EDGE-ON-HUDSON

APPLICATION FOR SITE PLAN & SUBDIVISION APPROVAL

PHASE ONE SUPPLEMENTAL SUBMISSION

Re: Phase 1 Site Plan and Subdivision Application
Edge-On-Hudson Riverfront Development
199 Beekman Avenue, Sleepy Hollow

LIGHTING ANALYSIS AND PHOTOMETRICS PREPARED BY LOUIS POULSEN, REPORT DATED JULY 15, 2015.

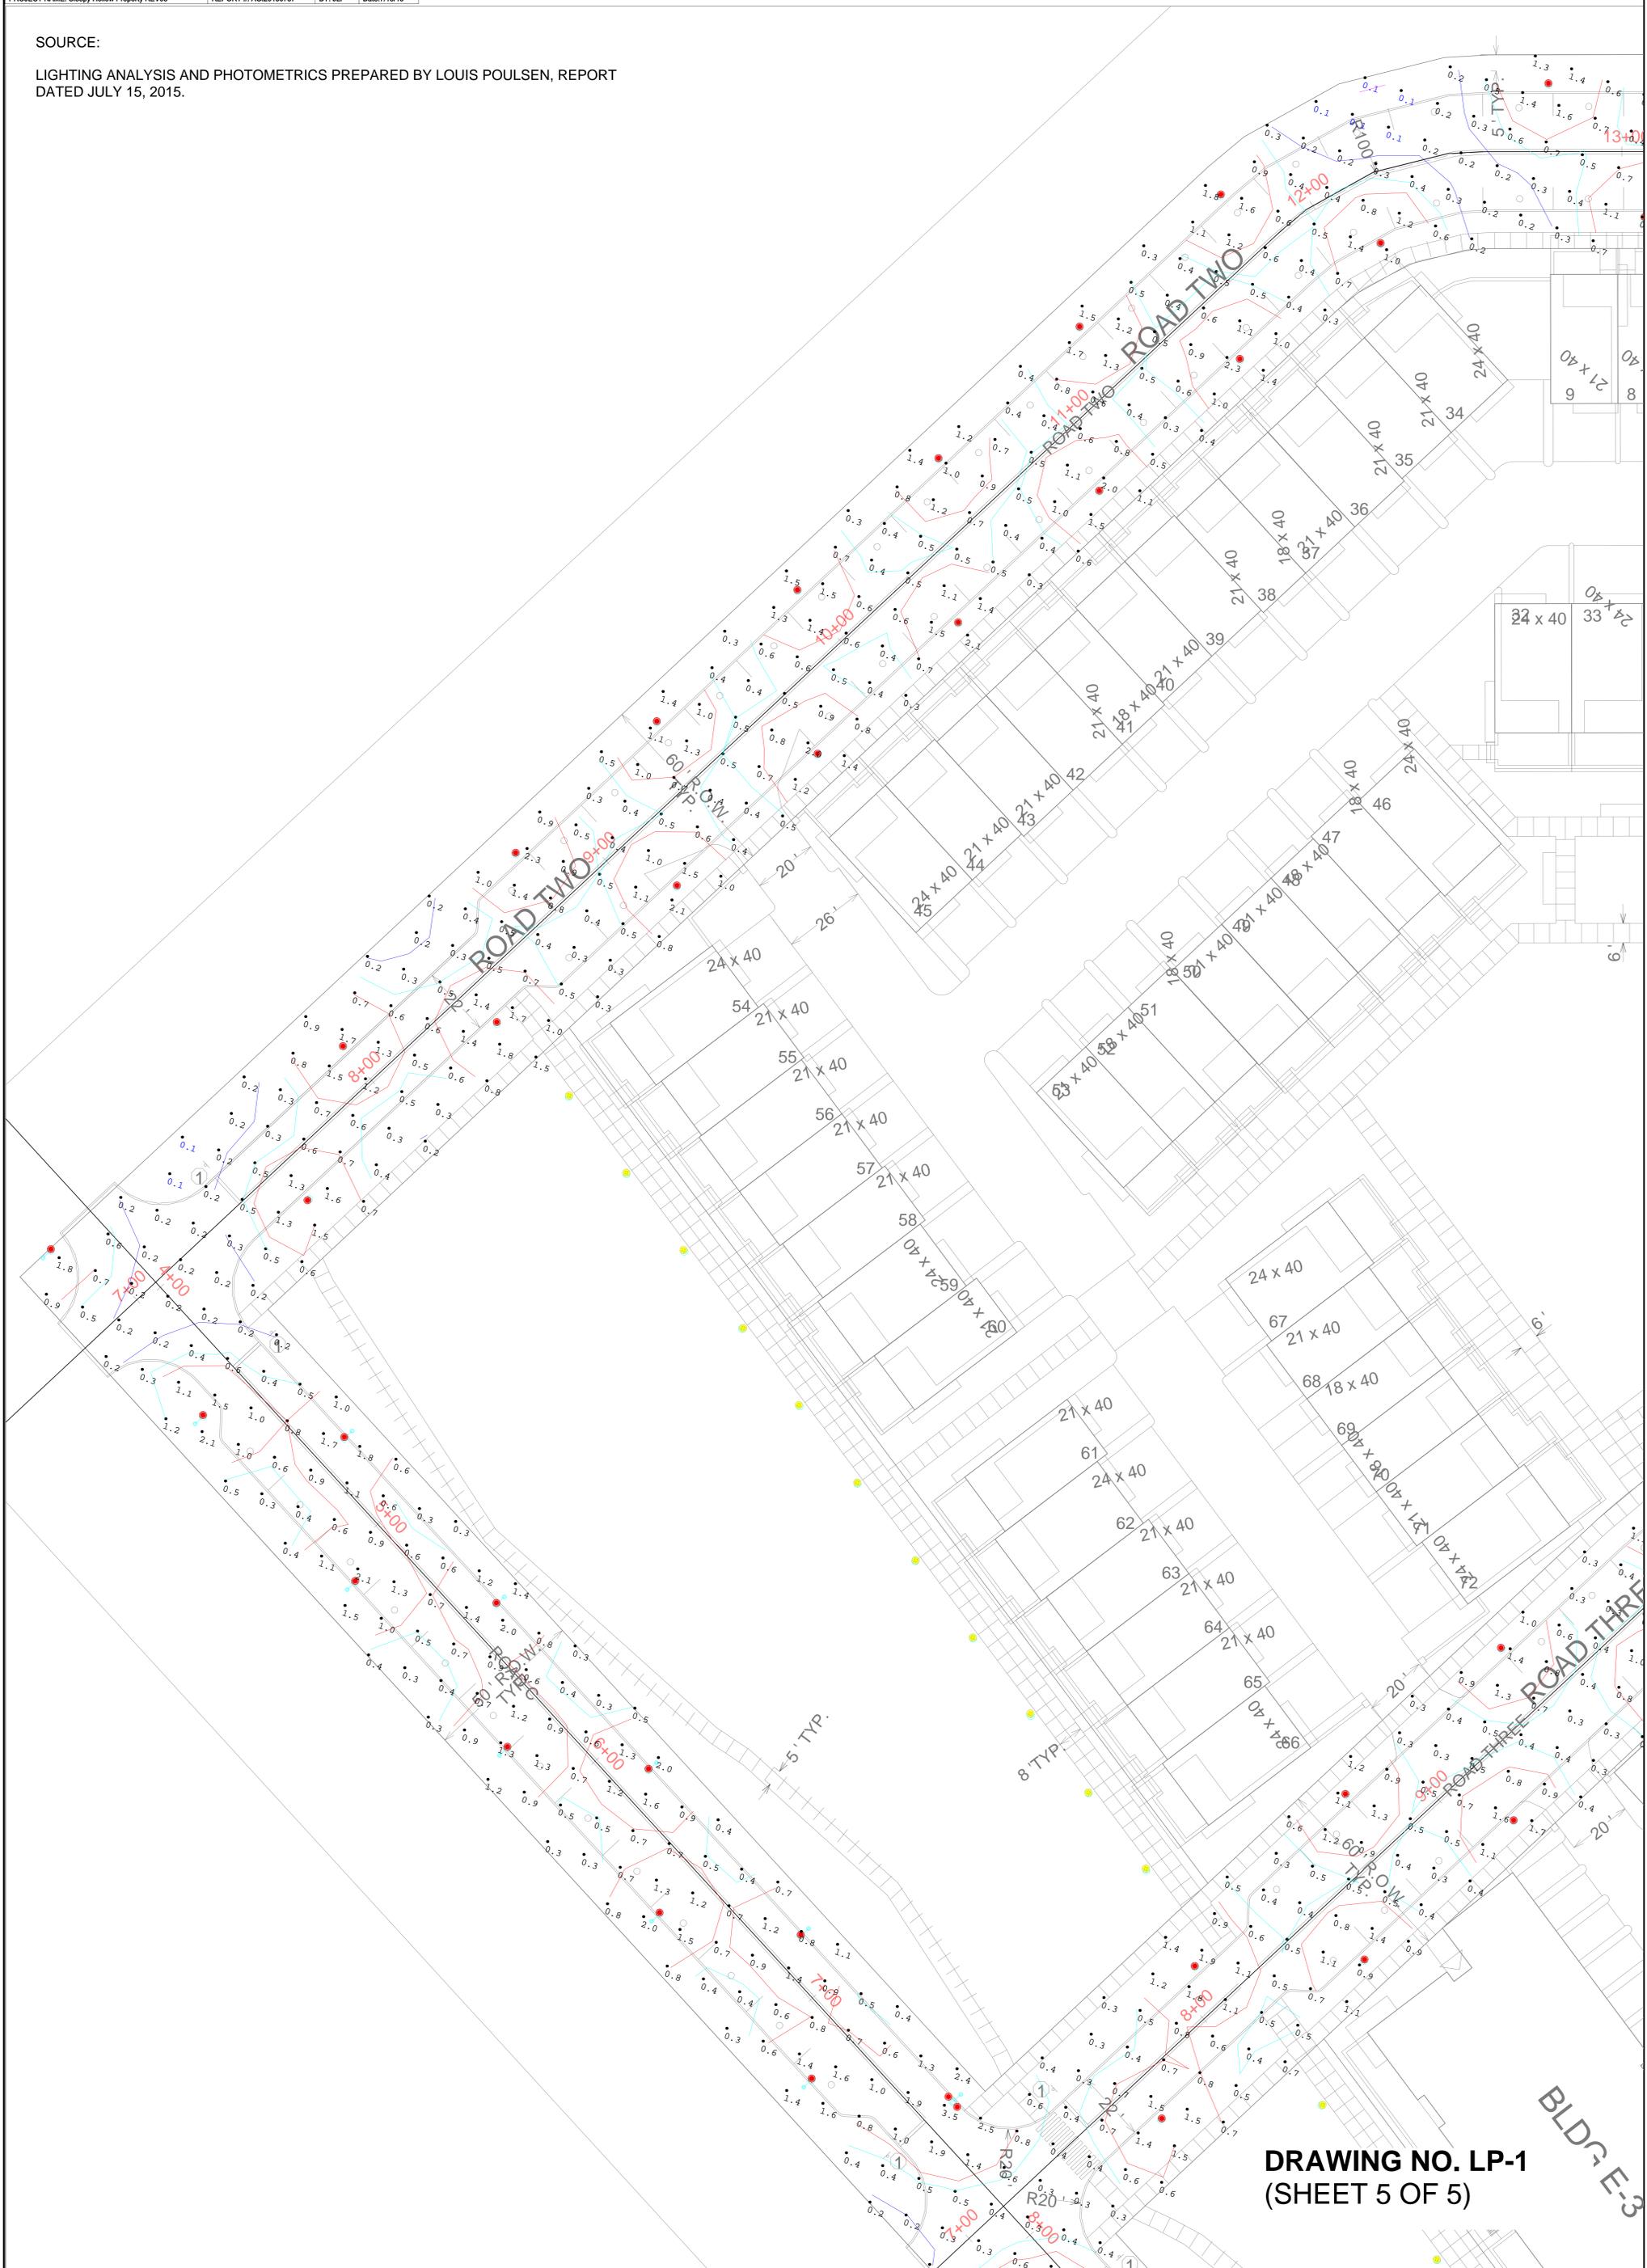
- G3. **Comment:** *A photometric plan must be submitted for review.*
- Response:** A photometric plan is included with this submission set and is appended to the engineering set of plans; see Sheets LP-1 through LP-4. The proposed street, pedestrian and bollard light fixtures are shown on page 9 of the attached Landscape Architecture Exhibit. The Edge-On-Hudson lighting concept is to utilize fixtures that reflect the regional character of the Hudson River Valley, complement the site furniture and knit together each district and the public realm. The uniformity in street lighting and pedestrian lighting will contribute to the sense of a pedestrian friendly network in addition to providing a

Street lighting (14' pole mounted) fixtures are located within the public rights-of-way. The sequence begins with metal-halide street light fixtures at the Beekman Avenue roundabout to provide a higher lighting level at that intersection and then transitions to LED fixtures within the Edge-On Hudson site. Pedestrian lighting consists of 12' pole mounted fixtures located along the Central Park sidewalk, within Block E and at the neighborhood open space area of Block J, as well as bollard lighting fixtures located along the mews and within entry courtyards. Internal residential access ways will also be lit by wall mounted fixtures located on garages within Blocks J and E.
